GS#610-012 MCM LeFleur's Bluff Park Improvements (Phase 2)  
Mississippi Department of Wildlife, Fisheries, and Parks

## ADDENDUM NO. 04

**A100**  
ARCHITECTURAL  
SITE PLAN

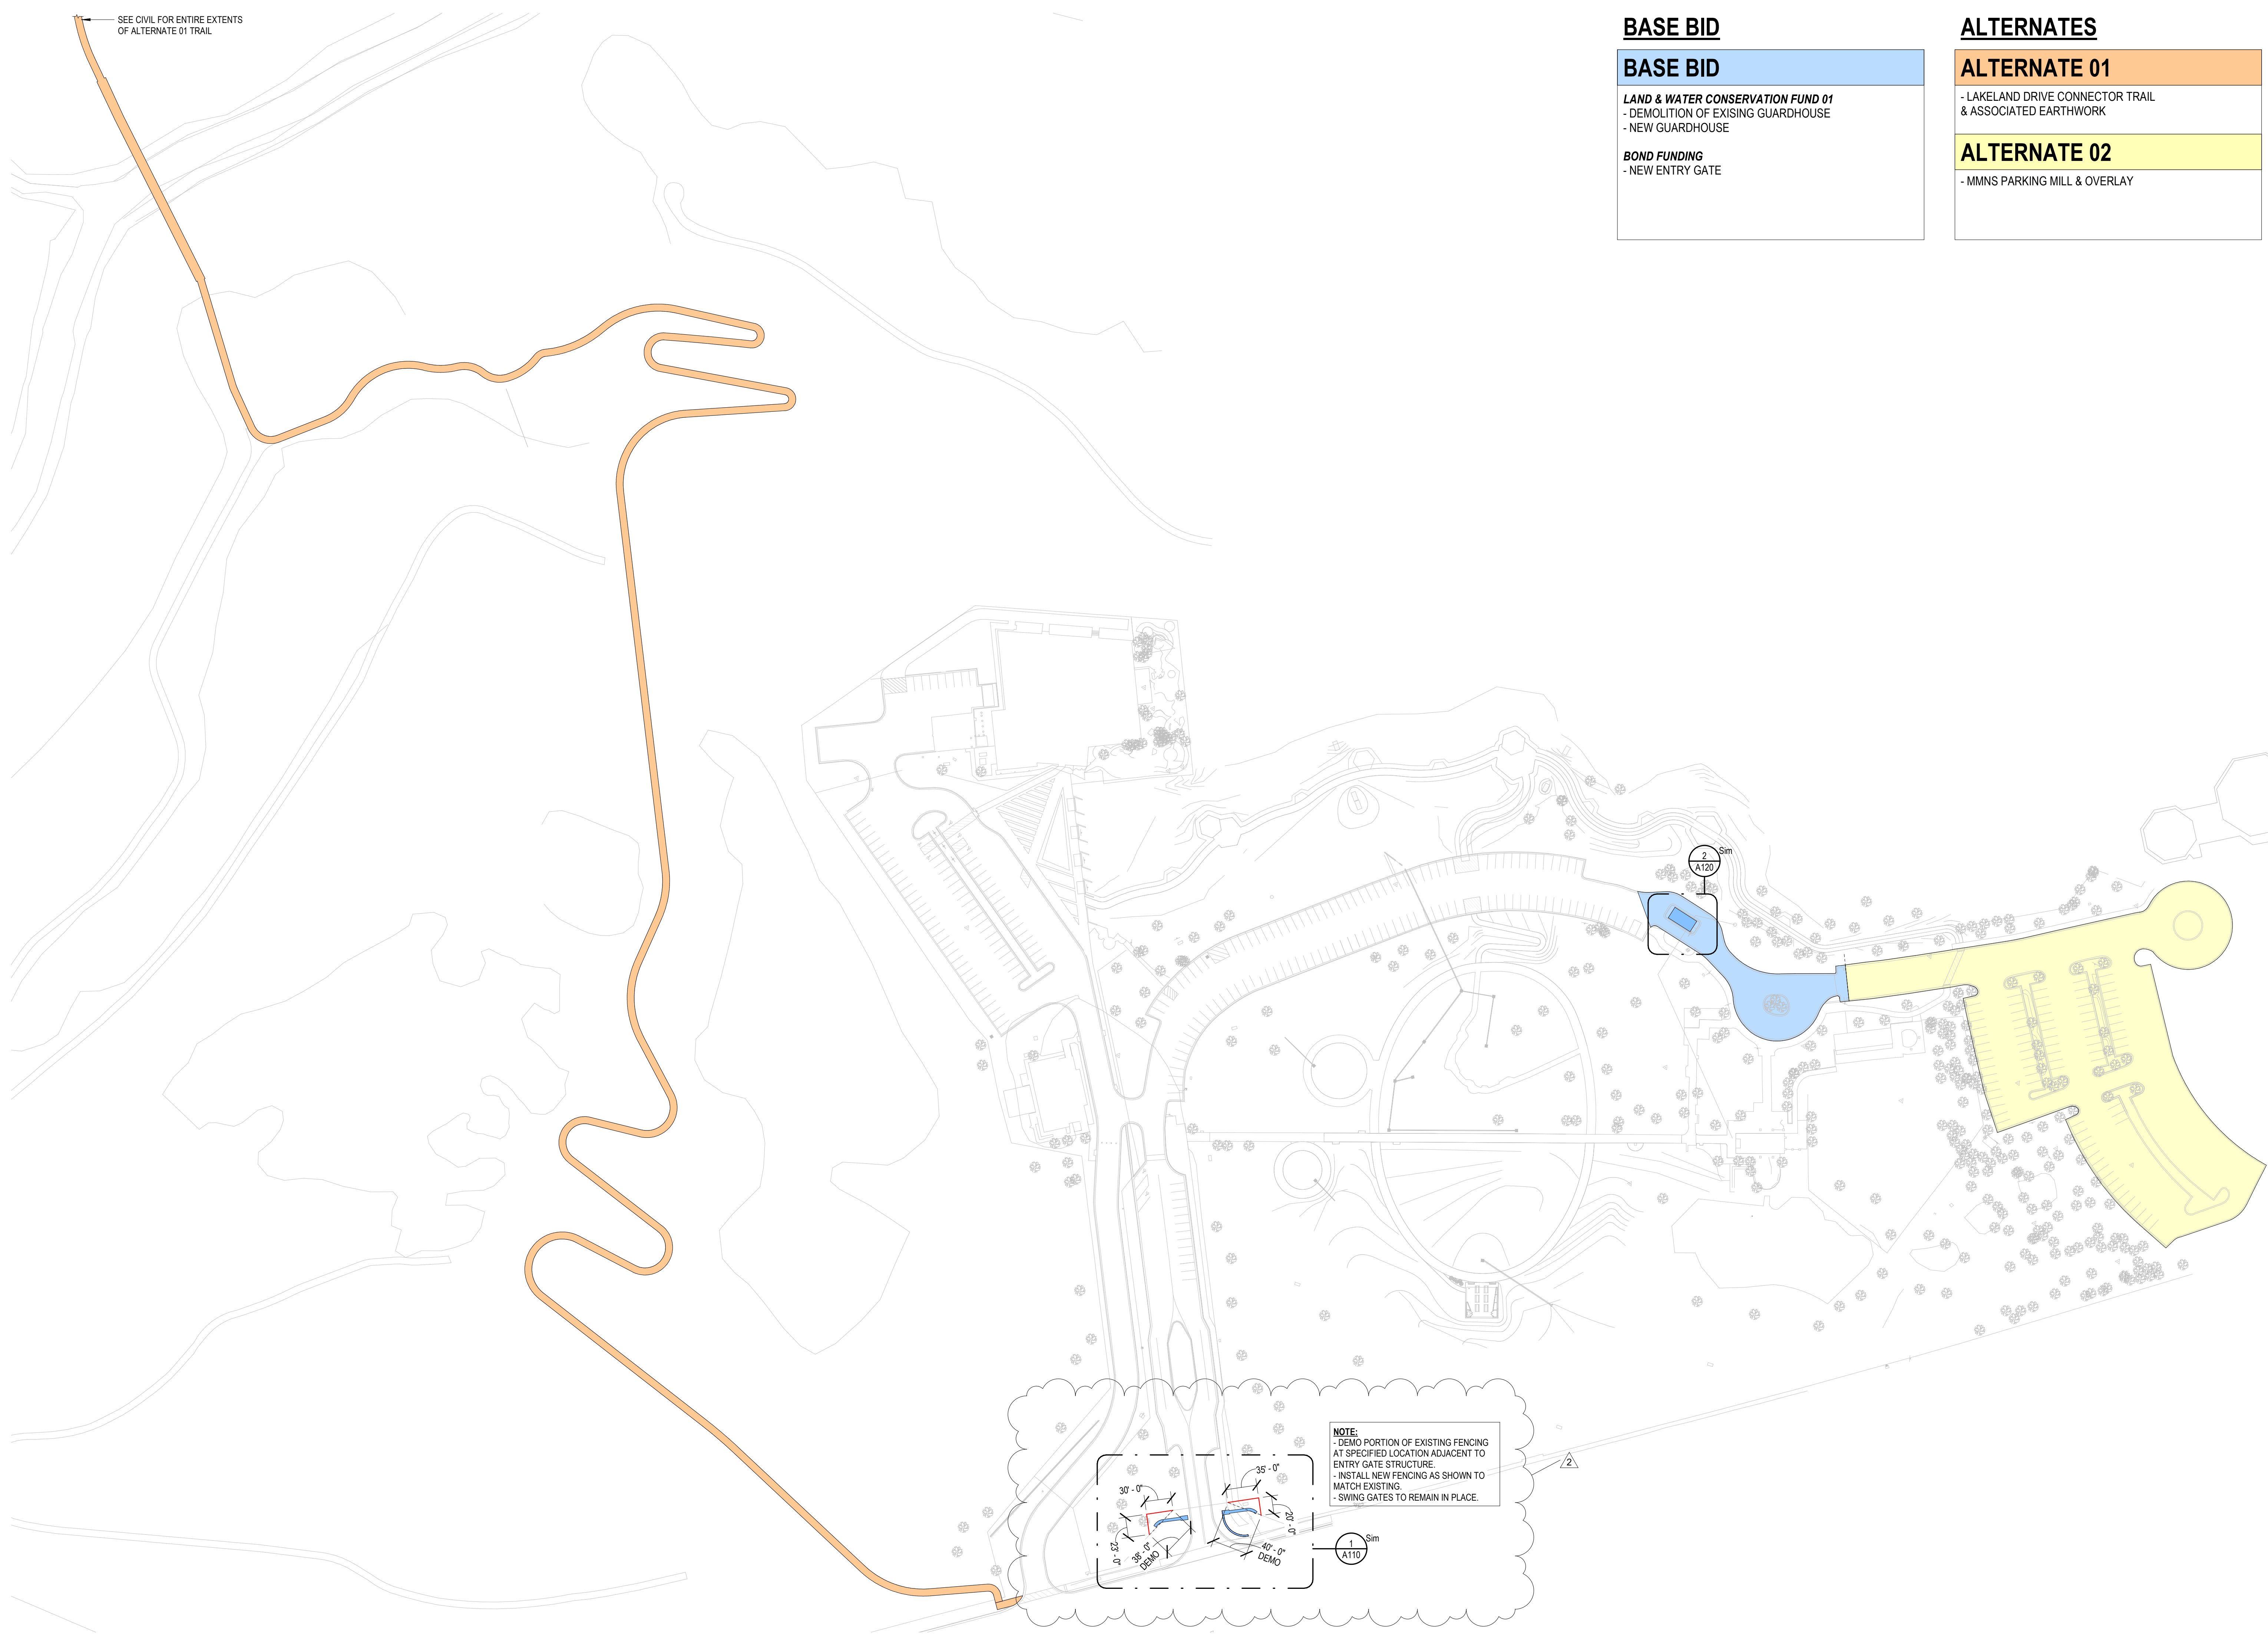
- ITEM NO. 03      A100 – ARCHITECTURAL SITE PLAN**  
**REPLACE** sheet with the attached **A100**.  
ADDS scope related to fencing at entry gate: demolition of portion of existing fencing and installation of new fencing to match existing. Swing gates to remain in place.
